# 303 MARINE DRIVE - 28 MAY 2018

# ISSUES FOR RECONSIDERATION

# STREET FRONTING TOWNHOMES

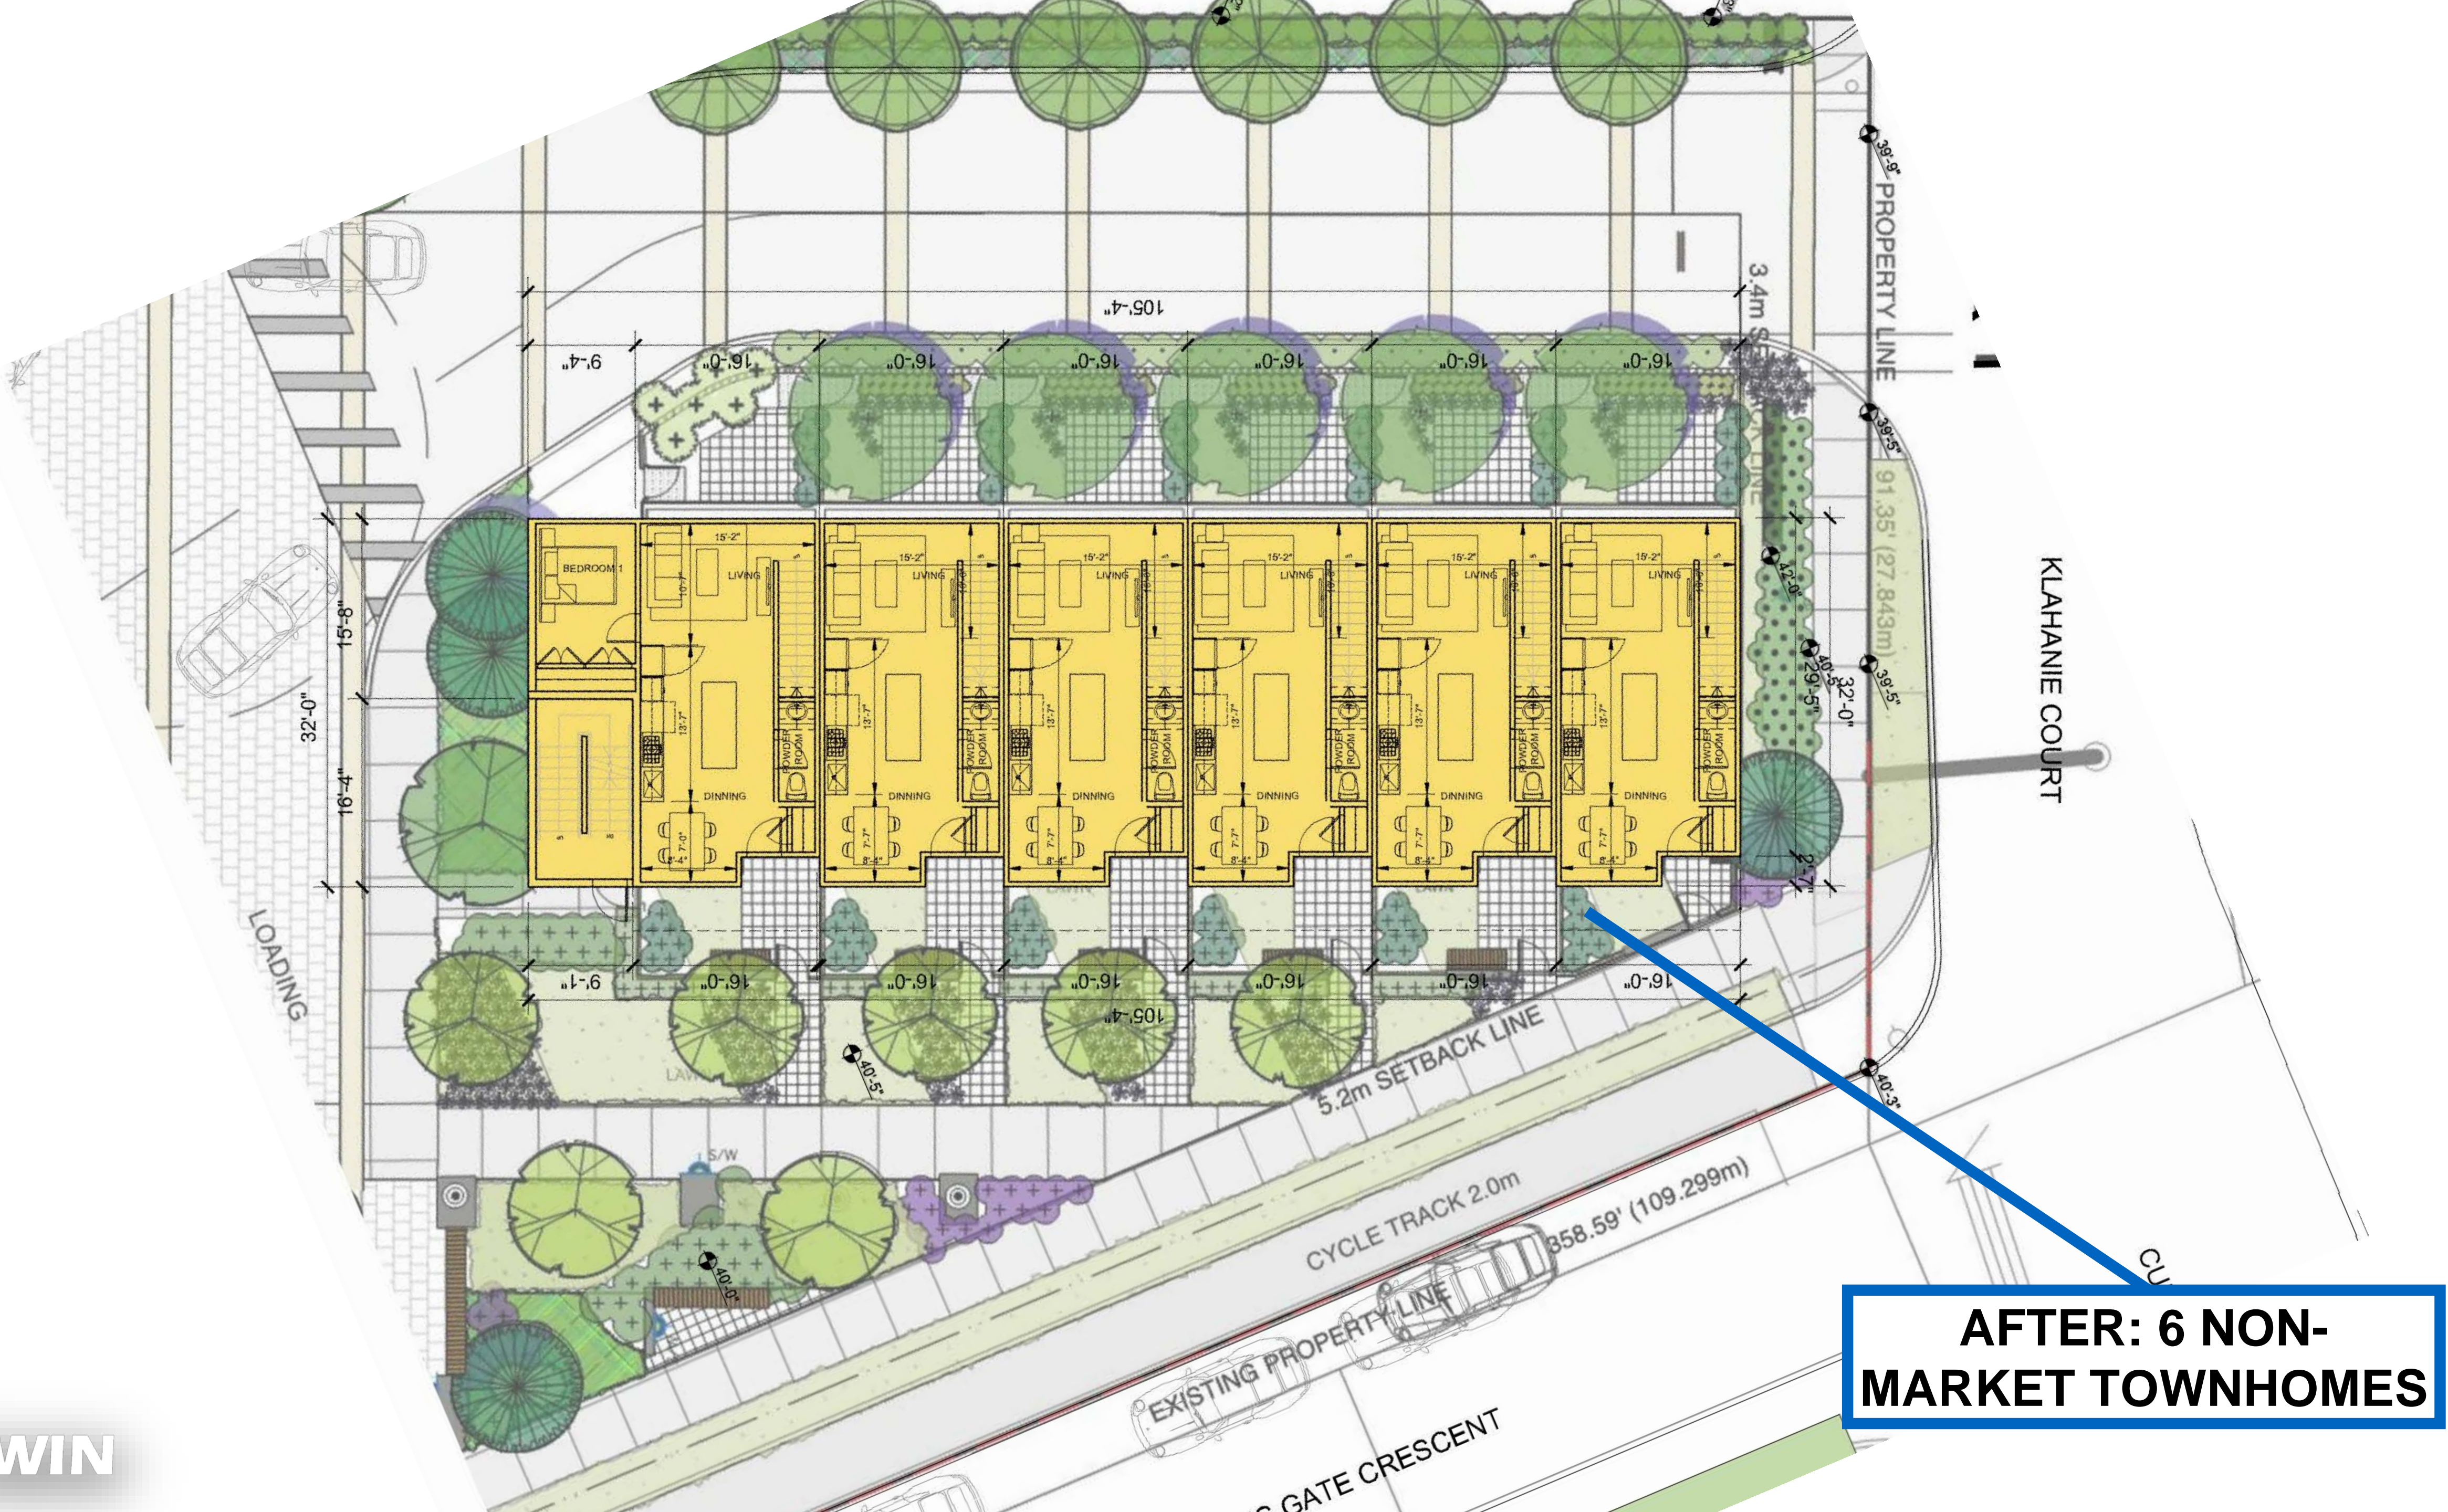
# NON-MARKET TOWNHOMES

- 4 'market for-sale' townhomes converted to 6 'non-market rental' townhomes
- 5 x 960sf 2 bedroom townhomes; 1 x 1,200sf 3 bedroom townhome
- Size, location and format of housing well-suited to a non-profit
- Operator-owned or District-owned, Darwin agreed to deliver as part of CAC
- YWCA proposed as operator, provide homes for single mothers with children

**BEFORE: 4  
MARKET  
TOWNHOMES**

**AFTER: 6 NON-MARKET TOWNHOMES**

# RENTAL - SMALLER HOUSING OPTIONS

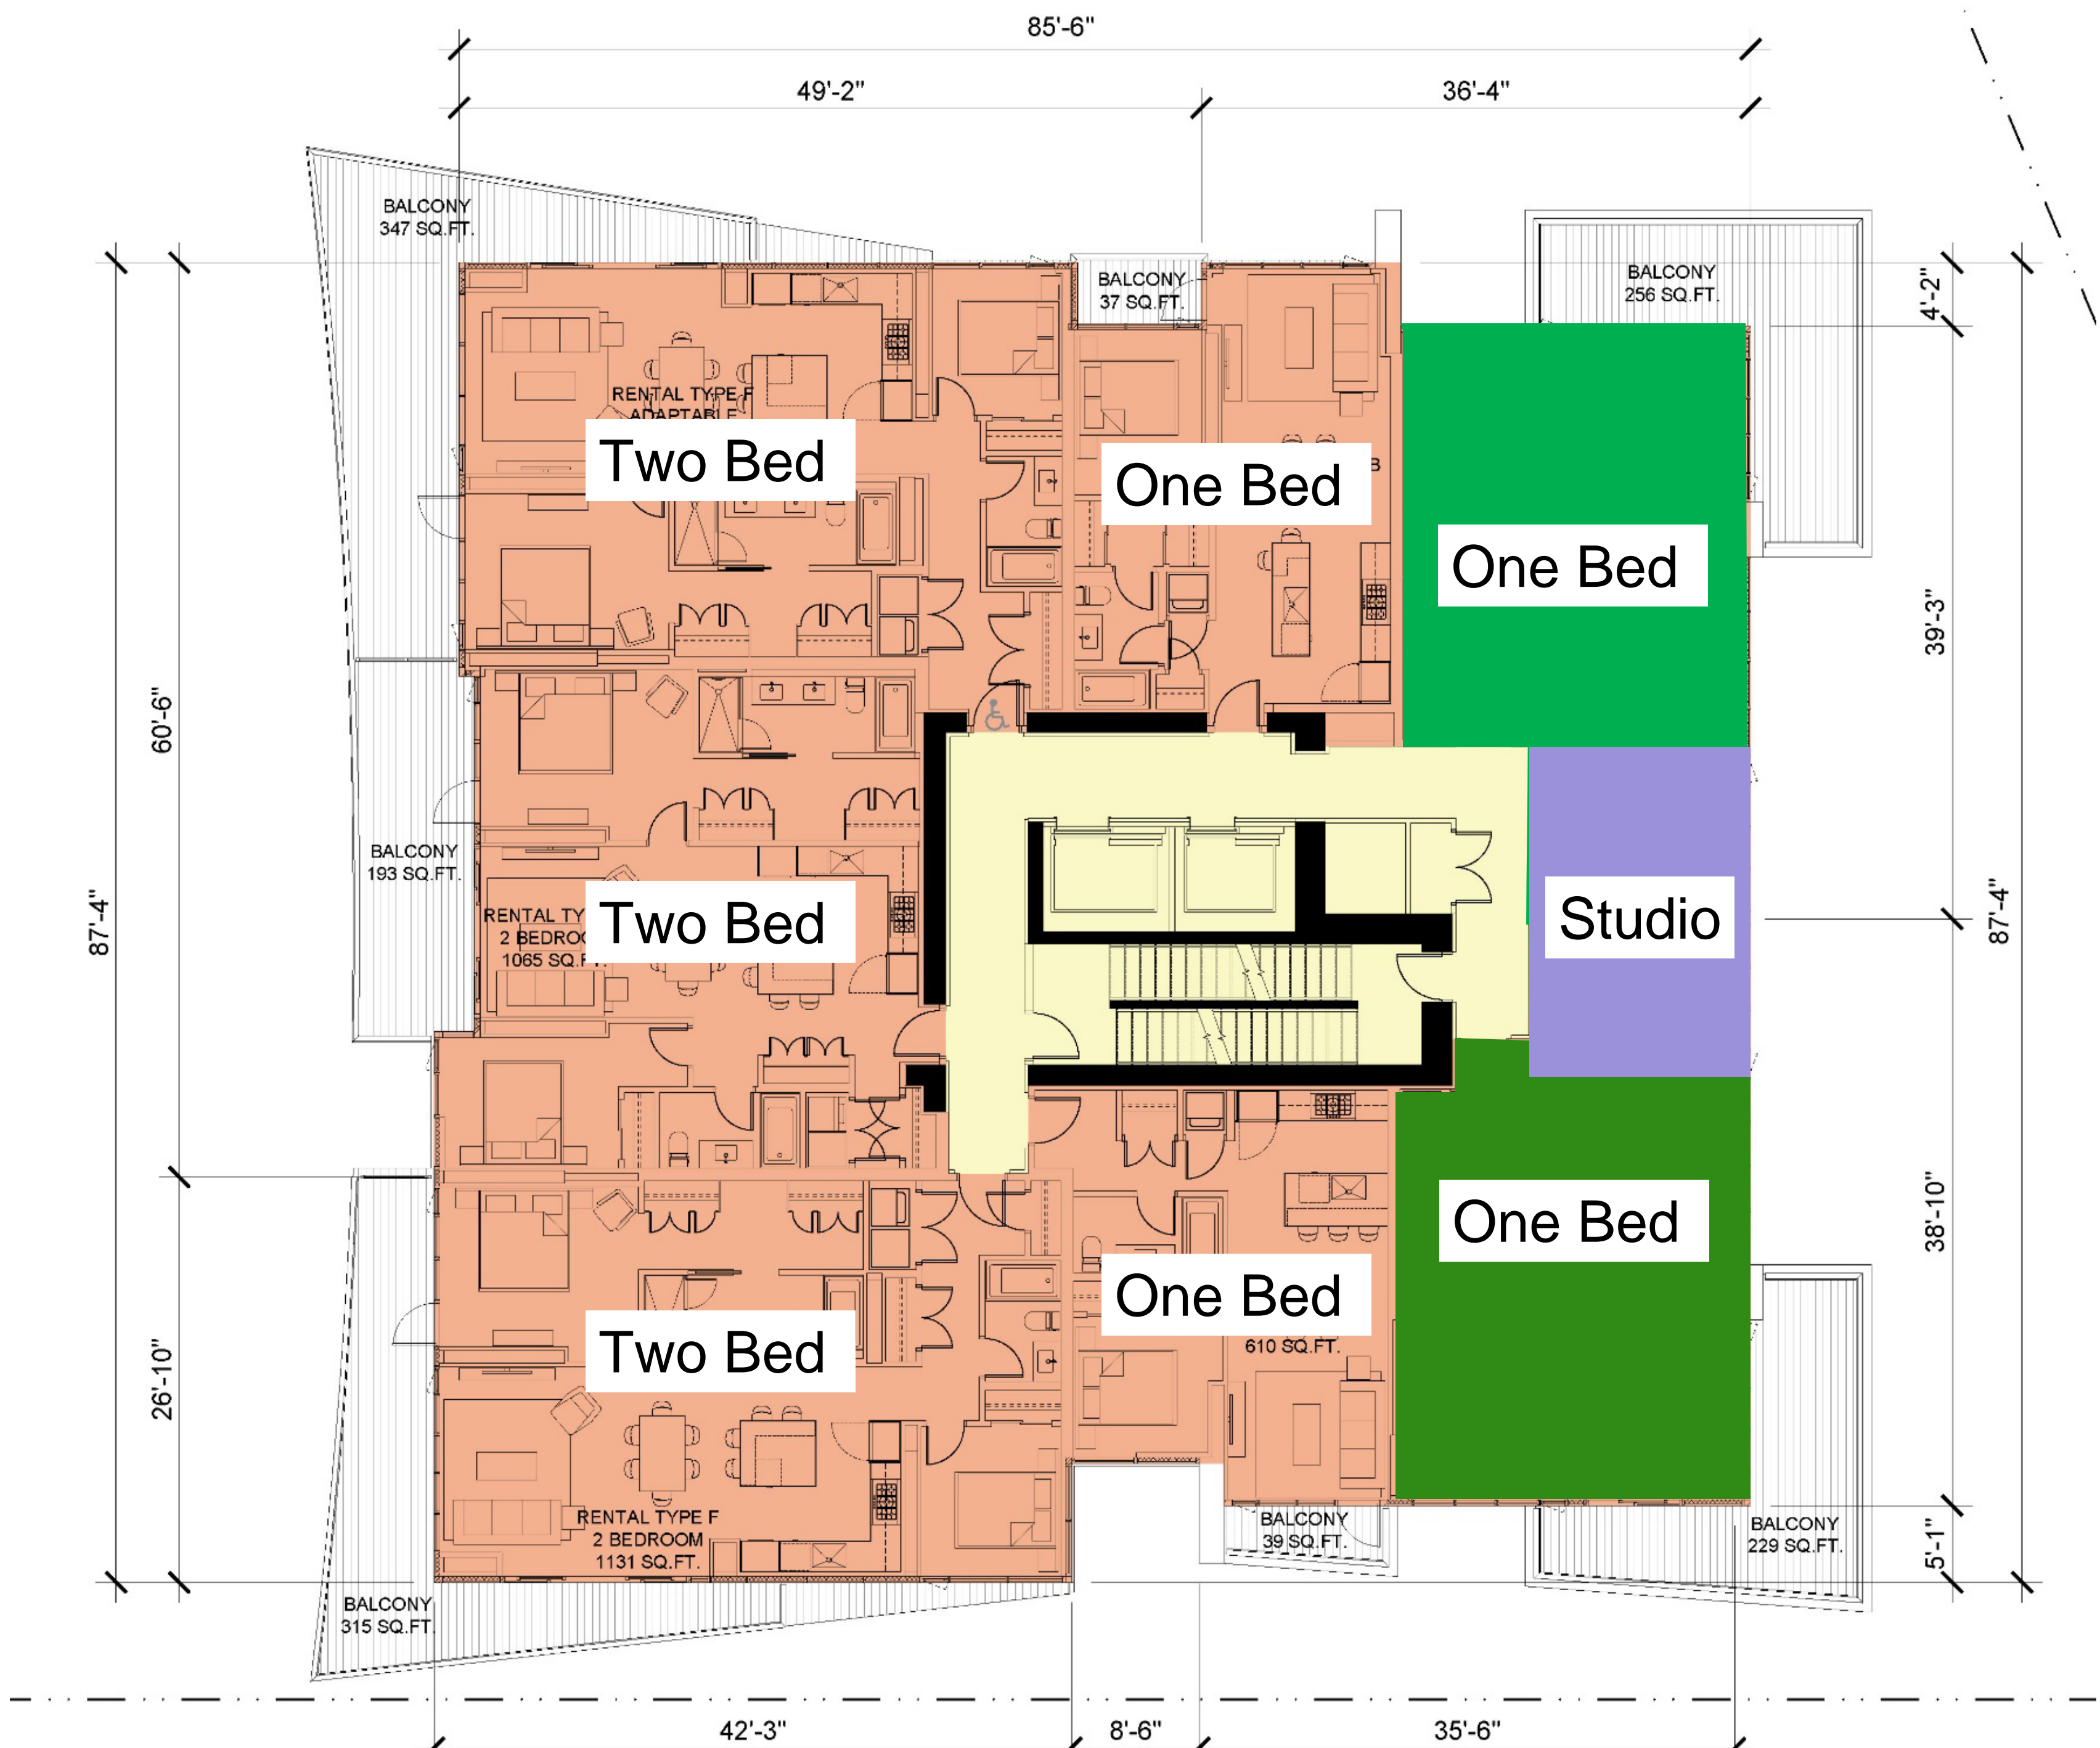
## BEFORE

Studio	N/A	0 (0%)
1 Bed	600 sf	12 (30%)
1+ / Jnr 2 Bed	820 sf	12 (30%)
2 Bedroom +	1,100 sf	18 (40%)
Townhouse	N/A	0 (0%)

## AFTER

Studio	300 sf	6 (11%)
1 Bed	600 sf	24 (44%)
1+ / Jnr 2 Bed	820 sf	0 (0%)
2 Bedroom +	1,100 sf	18 (34%)
Townhouse	N/A	6 (11%)
